CITY OF PORT WENTWORTH

PLANNING COMMISSION

JUNE 11, 2018

Site Plan Review Application submitted by Haydon Rollins, Hussey, Gay, & Bell, on behalf of CRN Development, LLC., for PIN # 7-0037-01-012 (Coldbrook Station Cir) for a Specific Development Site Plan to allow a multi-family apartment development in a P-R-M (Planned Residential Multi-Family) Zoning District

INTERSTATE HIGHWAY
NO. 95
400' PUBLIC R/W

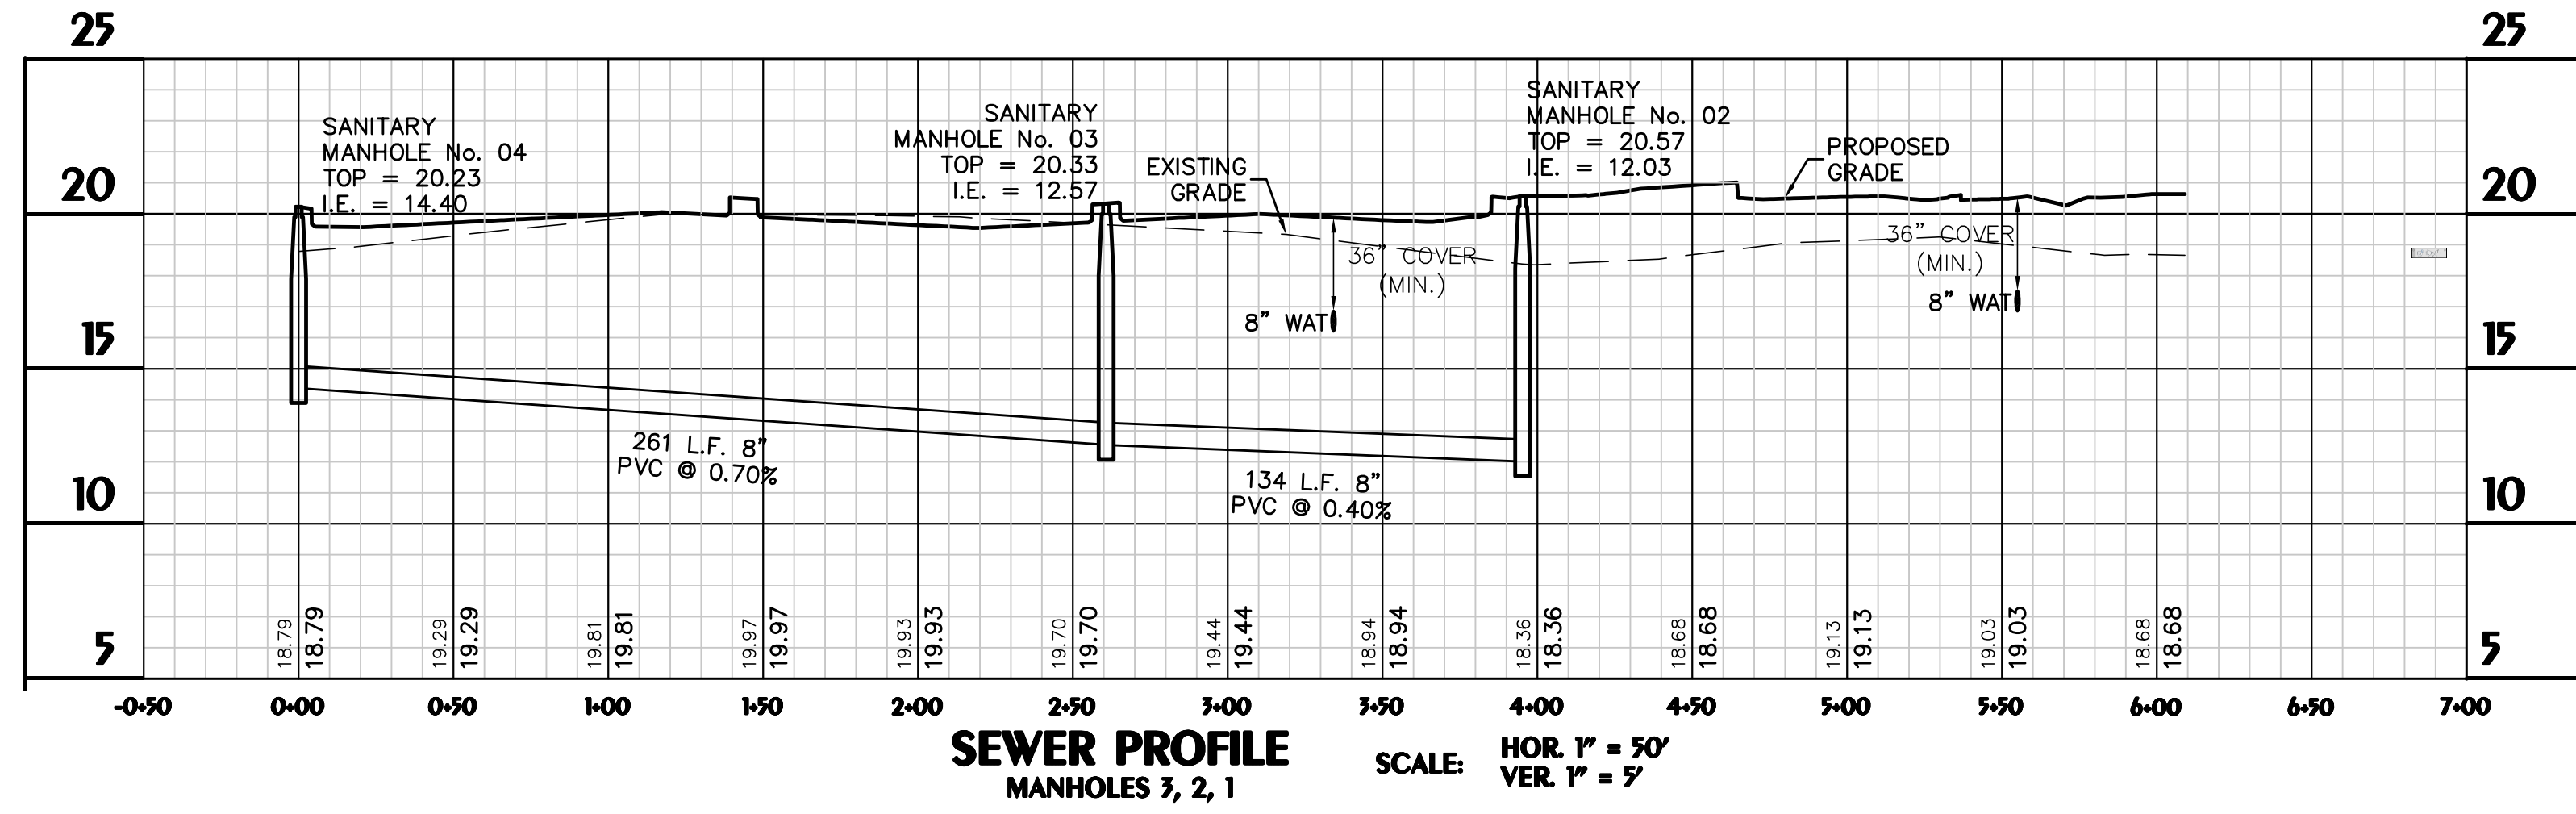
18. Provide storm drain profiles showing water or sewer crossings.
Acknowledged. Please see the revised plan sheet 9.
19. Add Pre vs. Post Development Detention Analysis for the 2-Year & 5-Year events to the Hydrology Report. *Acknowledged. Please see the revised hydrology report.*

9. Add back the water service manifold detail and provide backflow protection.
Acknowledged. Please see the revised plan sheet 11.
10. The 8" DIP water line downstream of Grade Inlet #4 shall have #57 stone placed between the intersection of the Mo pipes from the spring line of each pipe. *Acknowledged. Please see the revised plan sheet 9.*

DRAWING NUMBER
15
OF 26

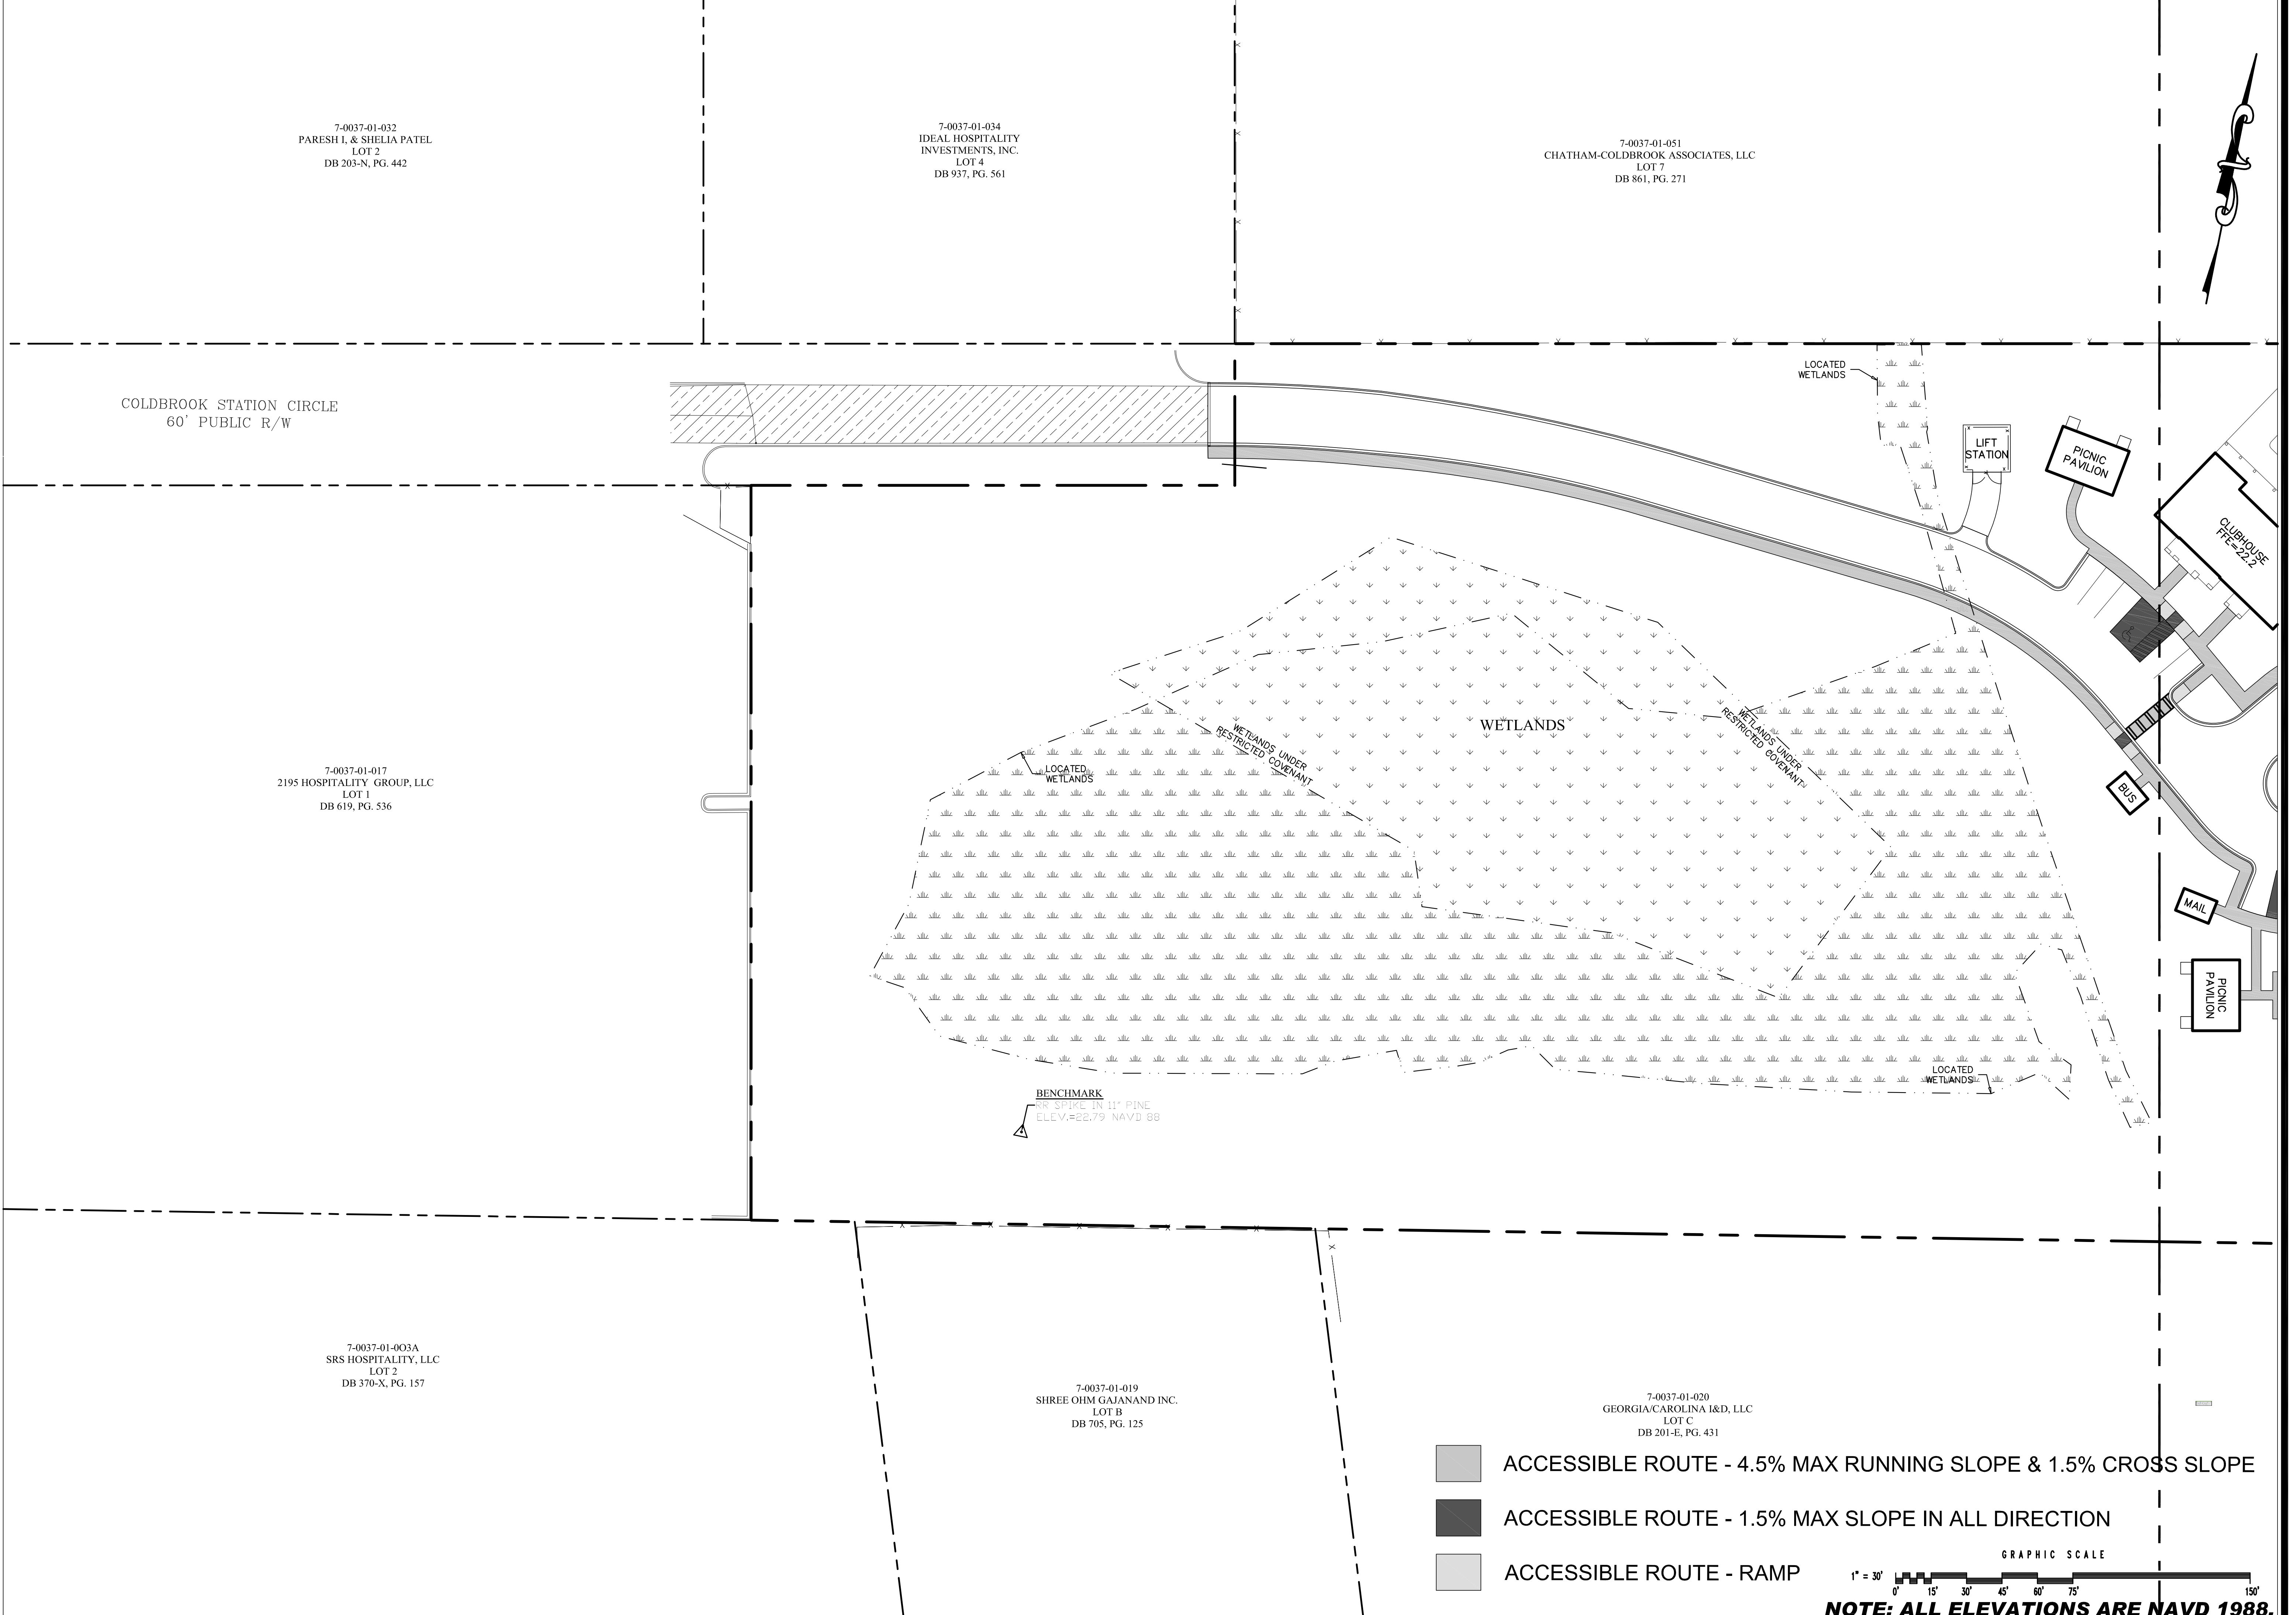
4. Does pump station have Fall prevention grating built into access hatch? If so please include. *Acknowledged. Please see the revised plan sheet 15 for the inclusion of safe hatch access by Xylem.*
